5AAP

TO	Whom It May Concern	EASD Territory Plan Unit
FROM	Alastair MacCallum	DATE 3 rd September 2011 PAGES 1
ITEM	Draft Variation No. 306

5AAP are a group of Canberra-based architectural practices who, since 2005, have been providing constructive feedback to ACTPLA (now EASD) on a range of planning issues and EASD service delivery. As a group we have recently reviewed DV 306 and provide the following comments for your consideration noting that we have also included a number of examples of completed residential developments including single dwelling to small and larger scale multi-unit development to demonstrate the impact of the proposed new Solar Envelopes. We believe there could be value in 5AAP meeting with EASD to present these 3d models to assist your team visualise the outcomes of the new solar envelopes against a range of previously approved developments.

BLOCK 5 SECTION 91, BRUCE

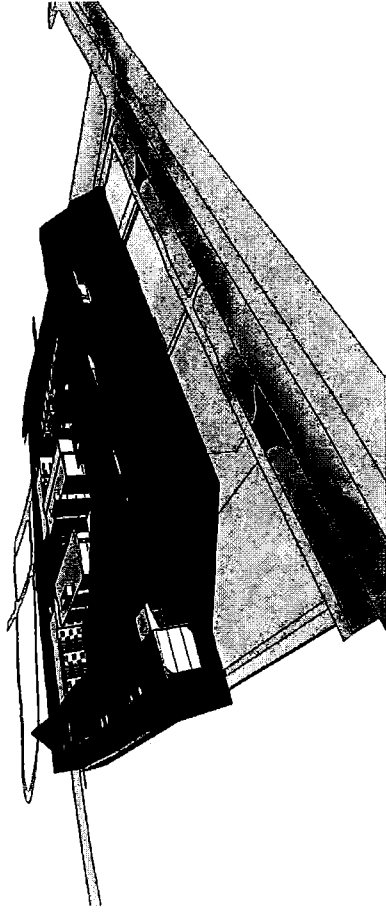
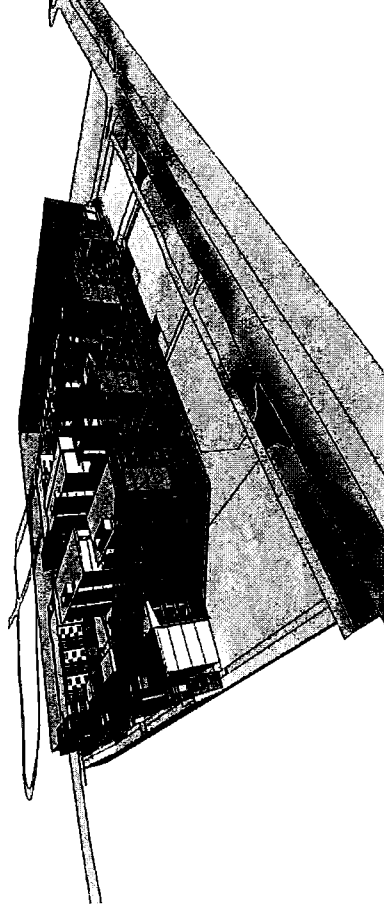
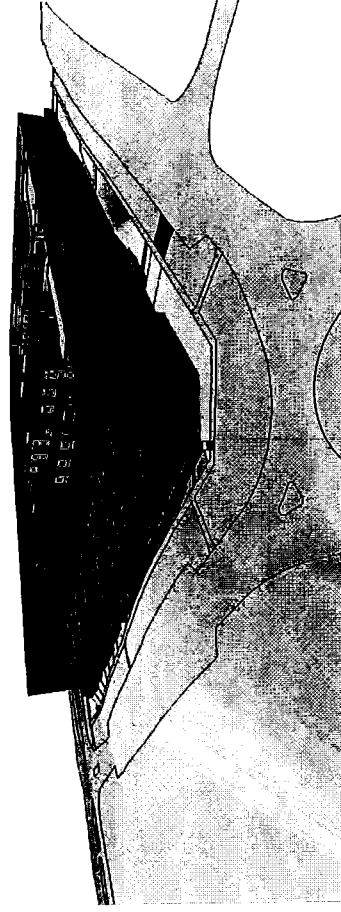
- New building envelope diagrams will be problematic for small RZ2, RZ3, etc. sites resulting in a strange built form, inefficient building design and significantly reducing redevelopment viability in areas that have been specifically zoned for urban infill and higher density. We have provided examples as attached.

BLOCK 18 SECTION 56, NARRABUNDAH

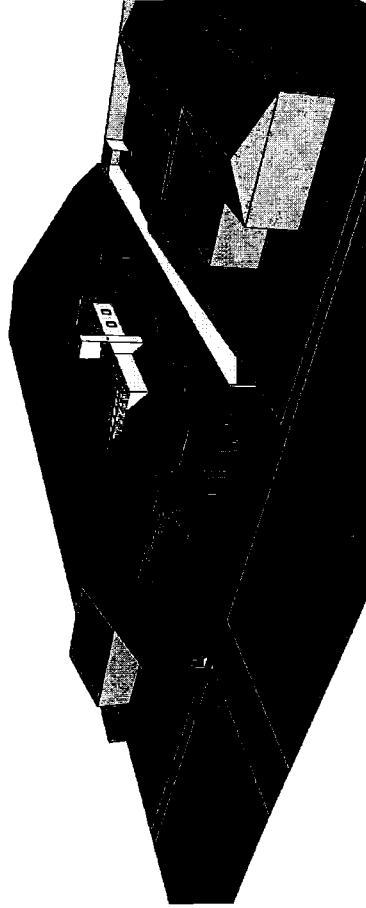
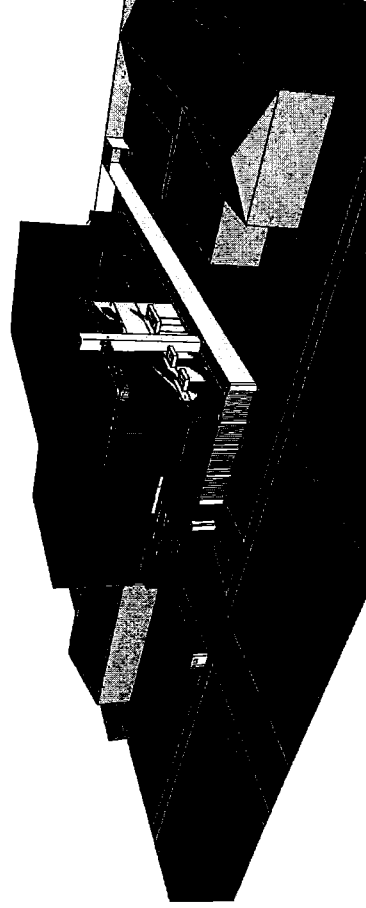
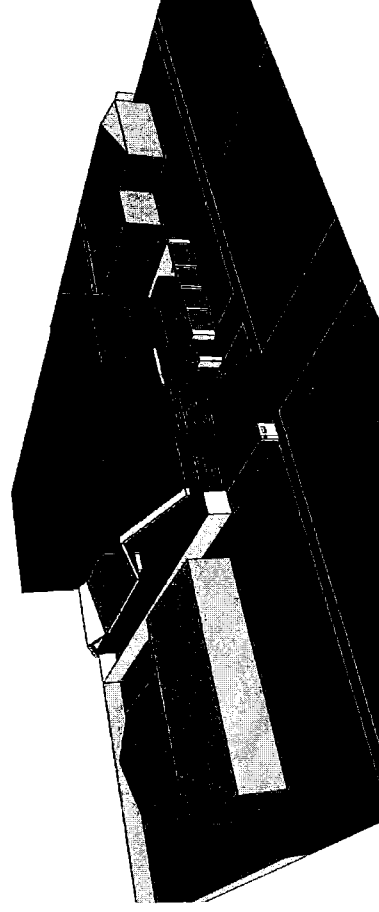
- The solar setback restrictions on southern sides of the block will push houses to the north creating wasted open space on the southern side. It would be a better planning solution to have open space to the north even with a little overshadowing noting the previous rule requiring access to three hours of winter sunlight was adequate.
